Human Factors Evaluation of the Tank, Combat
Full Tracked: 105mm Gun, M60

Consulting Report
February 1961

A report of work done in connection with Subtask VIII, FIREPOWER, Task 11-26,
"Methods for Improving Performance in Tank Gunnery"

POSTURE OF DRIVER, OPERATING WITH HATCH CLOSED

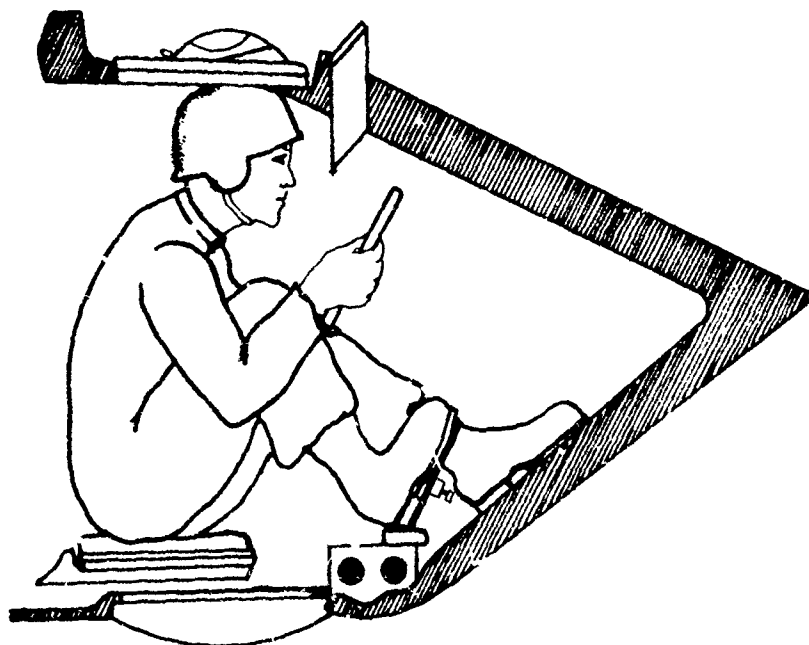
height, vertical space is still less than that required for efficient driving. The resulting cramped posture which the driver must assume (as shown in Figure 1) severely limits the length of time he is able to operate efficiently with the hatch closed.

Accelerator Pedal. The location of the accelerator pedal directly forward of the seat causes a very cramped posture when the driver is operating with the hatch closed. (See Figure 1.) In addition, the near vertical mounting of the pedal results in a sharp ankle angle, especially for slow speeds. When the hatch is open and the seat is up, the forward distance to the pedal is not very critical, but the vertical mounting of the pedal requires that the driver operate it by holding his foot on the upper edge with no anchor point on which to rest his foot. In both positions the accelerator is extremely difficult to operate, almost impossible when the driver is wearing overshoes or arctic boots.

DRIVER'S POSTURE AFTER RELOCATION OF ACCELERATOR PEDAL

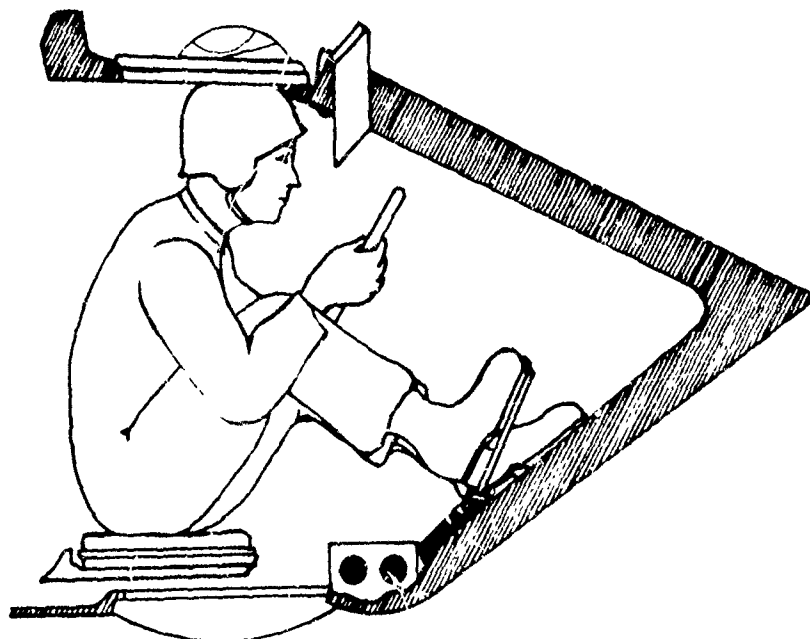
One solution to this problem would be to move the pedal approximately six inches forward; this change would also raise the height of the pedal about four inches. Operation with the hatch closed and with the pedal relocated forward is depicted in Figure 2. It can be seen by comparing this figure with Figure 1 that this solution alleviates the difficulty somewhat without requiring a drastic modification.

Location of Brake Pedal and
Linkage

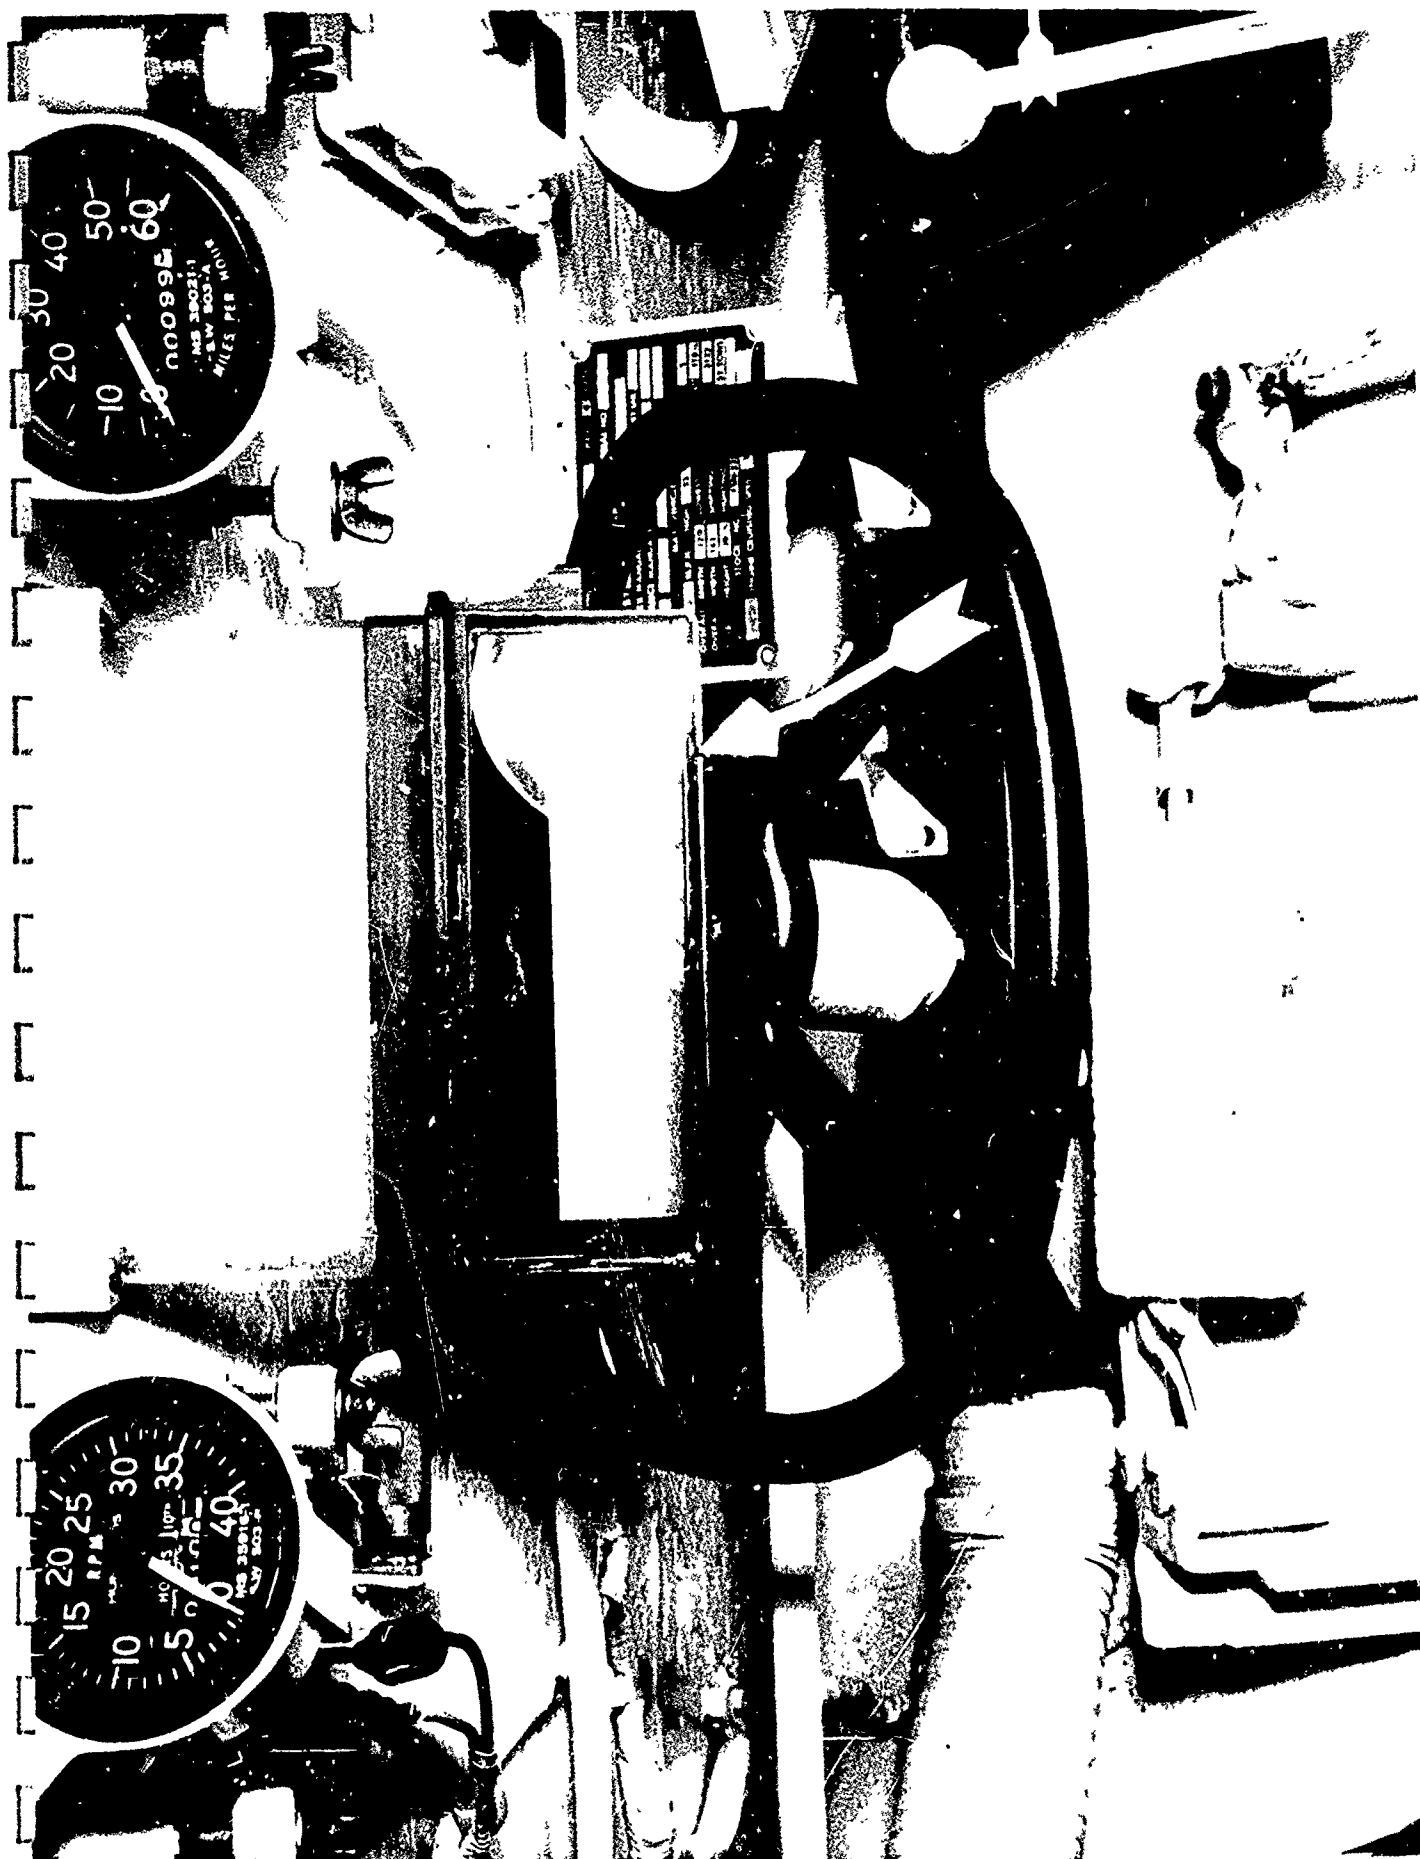
Brake Pedal. The location of the brake pedal, high on the hull and directly behind the steering wheel, requires most drivers to bend their leg around the wheel to brake. This requirement and the force necessary to operate the pedal make braking extremely difficult. Obviously the brake pedal should be relocated, but to what position is not readily apparent.⁴ Relocation

is further complicated by the large amount of linkage required to operate the present braking system. (See Figure 3.) This linkage restricts not only the number of possible pedal locations, but also the location and operation of the other controls. Some method of assisted braking, such as hydraulic brakes, which would reduce the amount of linkage required, would greatly reduce clutter and interference and allow for proper location of the braking controls.

Driver's Line of Sight over the
Center Periscope When the Seat Is
Adjusted to Maximum Height

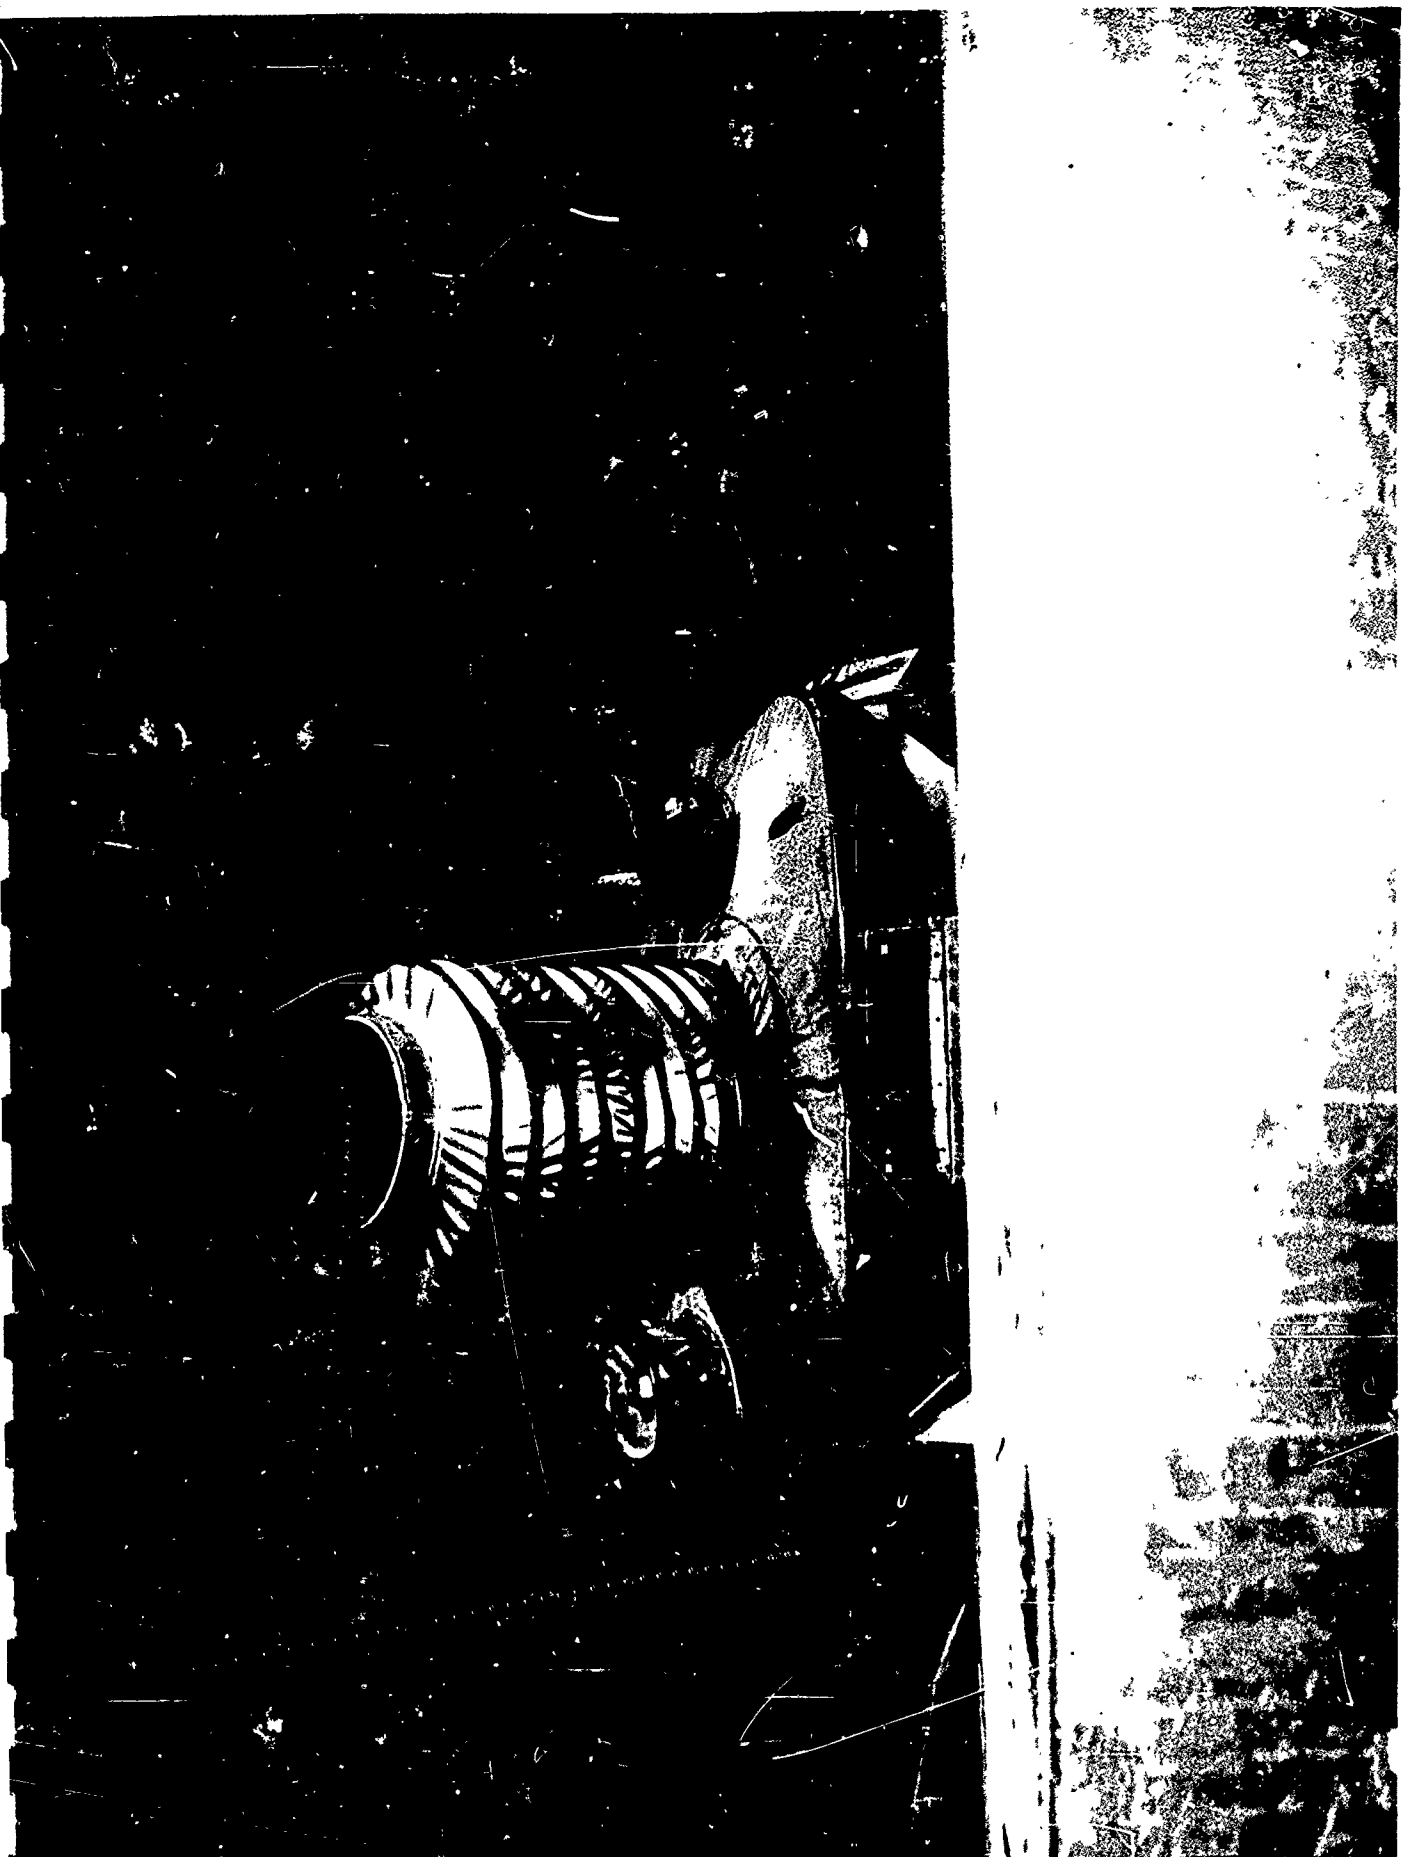
Third, the vertical distance from the top of the driver's seat to the tops of the vision blocks is 29 inches. This distance will be increased when the M48A2 bucket-type seats are used. Since the eye level of the 75th percentile man in a normal sitting position is only 30.4 inches, the majority of drivers cannot now observe the immediate frontal area when they are

operating with the hatch open. (See Figures 5 and 6.) To increase frontal vision, the driver must either remove the block or use some method of increasing the height of the seat (some drivers use seat cushions; others drill an extra hole at the top of the seat adjustment bar). Removal of the block would not be permitted in a combat situation where a quick change from hatch-open to hatch-closed operation might be necessary. Raising the seat raises the driver enough that he might be accidentally hit by the gun shield. One suggested solution is a quick adjusting up-down case for this vision block. Another suggestion is to increase seat height (as shown in Figure 7), and add a device to protect the driver from the gun shield.

Figure 8:
Suggested Schema for
Speedometer - Odometer

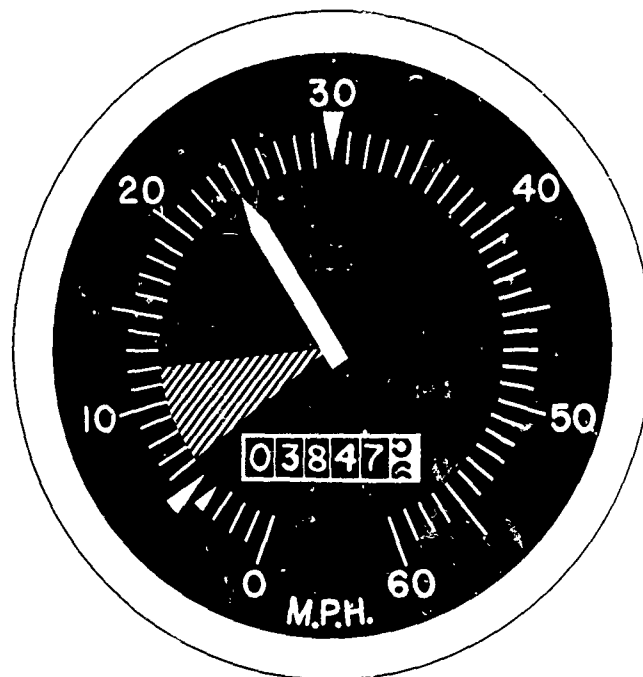
Zones or distinctive marks could also be added to the speedometer to identify critical speeds. One possible schema, shown in Figure 8, provides for a distinction at the 4 MPH position for towing, at 5 MPH for traveling in reverse or for ascending or descending steep grades, between 6 and 12 MPH for shifting from low to high or from high to low and for showing maximum speed in low gear, and at 30 MPH for showing maximum speed on a hard surface.

Figure 9:
Suggested Schema for
Tachometer - Hour Meter

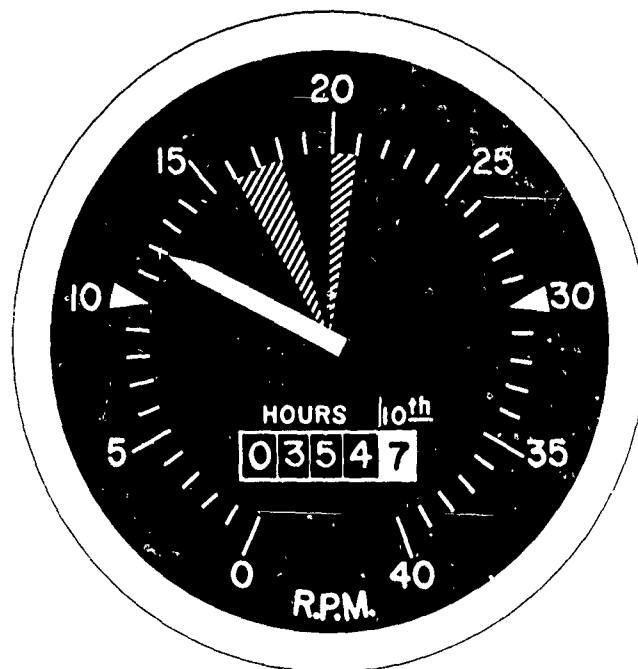
operations. Color zoning could be added to the tachometer as an aid. One possible schema, shown in Figure 9, includes a separation or distinctive marks between zones—one at 1000 RPM for operation before shutting the engine off, a color zone for the 1600 to 1800 RPM area for engine warm-up, a mark or separation at 3000 RPM to indicate that brakes should be applied in negotiating a steep down grade, and perhaps a zone in the 2000 to 2100 RPM area to indicate the optimum RPM for normal operation.

Loader's View of Replenisher
Cylinder Indicator Tape

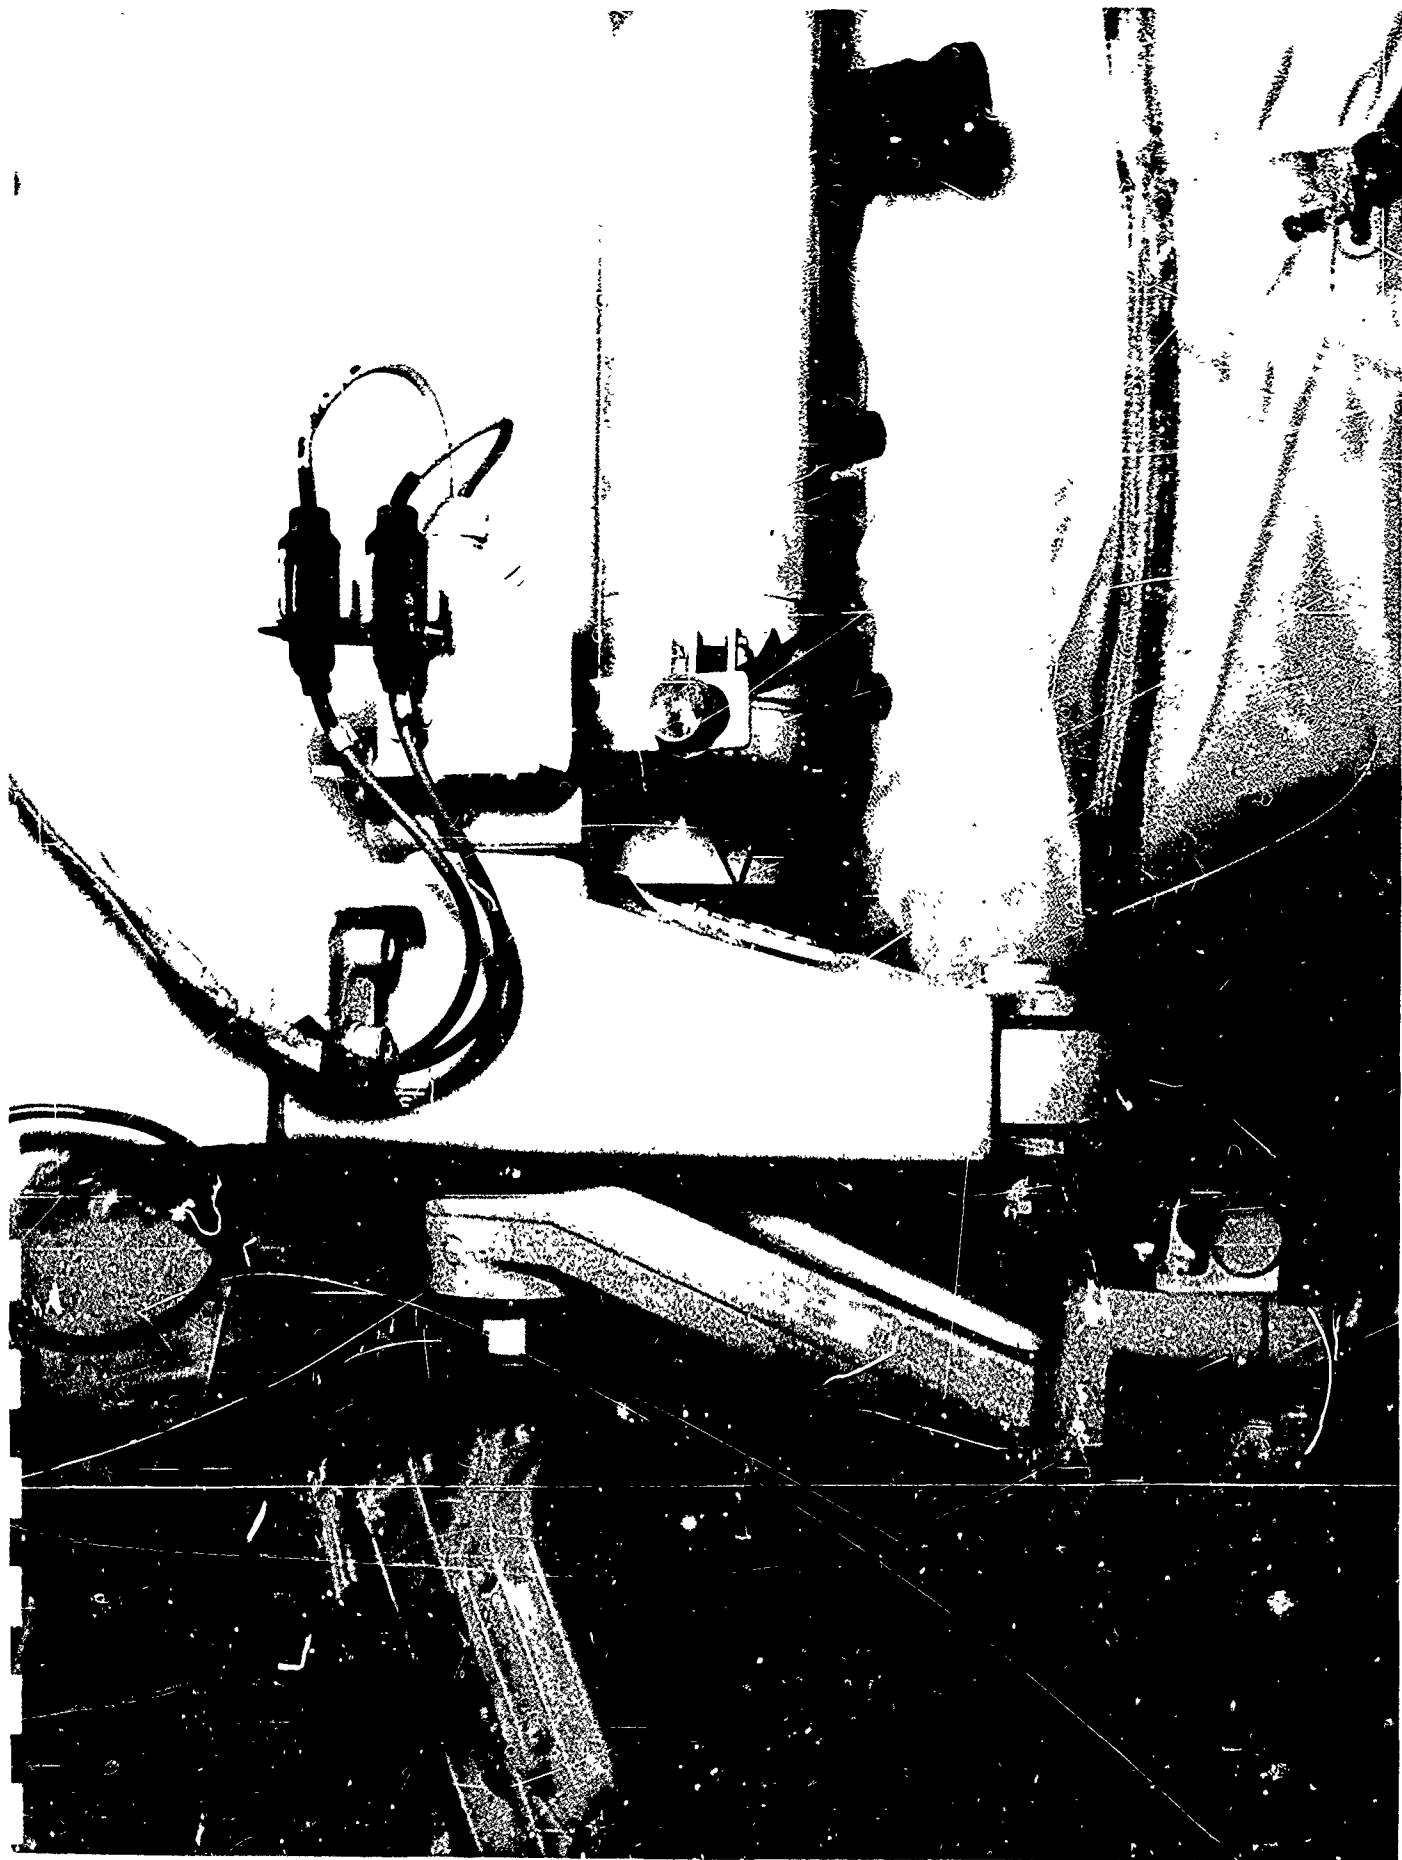
Replenisher Cylinder Indicator Tape. Before, during, and after firing, the loader should check the indicator tape marking to insure the correct fluid level. With the tape in its present position, the markings are not visible to the loader (as shown in Figure 12), and when the ammunition racks are full, the markings cannot be readily checked by feel. However, if the replenisher cylinder were moved several inches to the right, the loader would have an unobstructed view of the tape markings.
